Product/Process Change Notice (PCN)							
<input type="checkbox"/> Major Change <input checked="" type="checkbox"/> Minor Change							
PCN Number: PCN_FrqXTAL_20250211 Affected Series: WE-XTAL Affected Part Number: 830108091501, 830107834801, 830108211801 PCN Date: 2024-11-11 (YYYY-MM-DD) Effective Date: 2025-02-11 (YYYY-MM-DD)	Change Category: <input type="checkbox"/> Equipment/Location <input checked="" type="checkbox"/> General Data <input type="checkbox"/> Material <input type="checkbox"/> Process <input type="checkbox"/> Product Design <input type="checkbox"/> Shipping/Packaging <input type="checkbox"/> Supplier <input type="checkbox"/> Software						
Contact: Product Management Phone: +49 (0) 7942 - 945 5001 Fax: +49 (0) 7942 - 945 5179 E-Mail: pcn.eisos@we-online.com	Datasheet Change: <input checked="" type="checkbox"/> Yes <input type="checkbox"/> No Attachment: <input type="checkbox"/> Yes <input checked="" type="checkbox"/> No

3. Correction of the Product Dimensions:

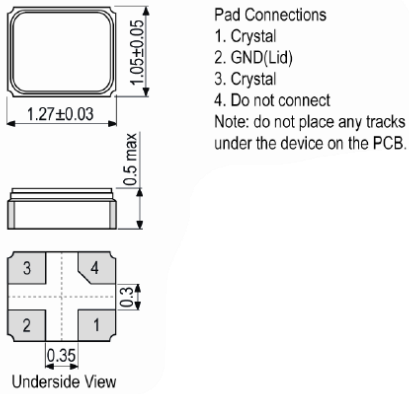
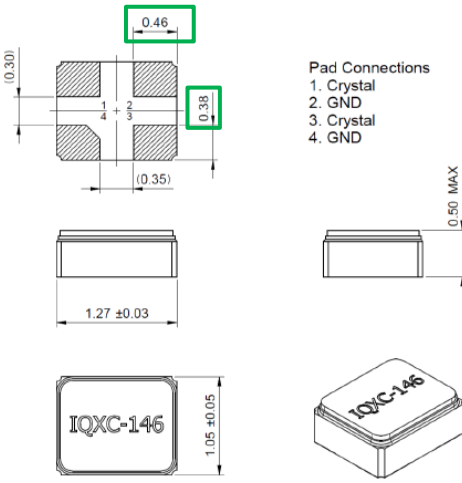
Before	After
Product Dimensions	 <p>Pad Connections 1. Crystal 2. GND(Lid) 3. Crystal 4. Do not connect Note: do not place any tracks under the device on the PCB.</p>	 <p>Pad Connections 1. Crystal 2. GND 3. Crystal 4. GND</p>

4. Correction of the typical frequency stability graph:

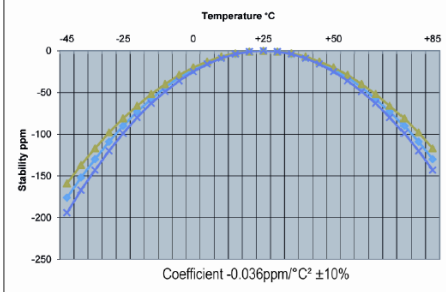
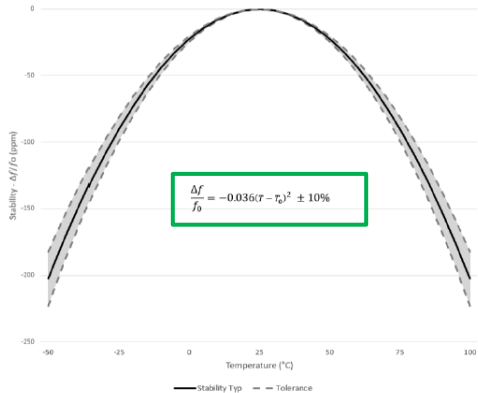
Before	After
Typical Frequency Stability Characteristics	 <p>Coefficient -0.036ppm/°C² ± 10%</p>	 <p>$\frac{\Delta f}{f_0} = -0.036(\tau - \tau_0)^2 \pm 10\%$</p>
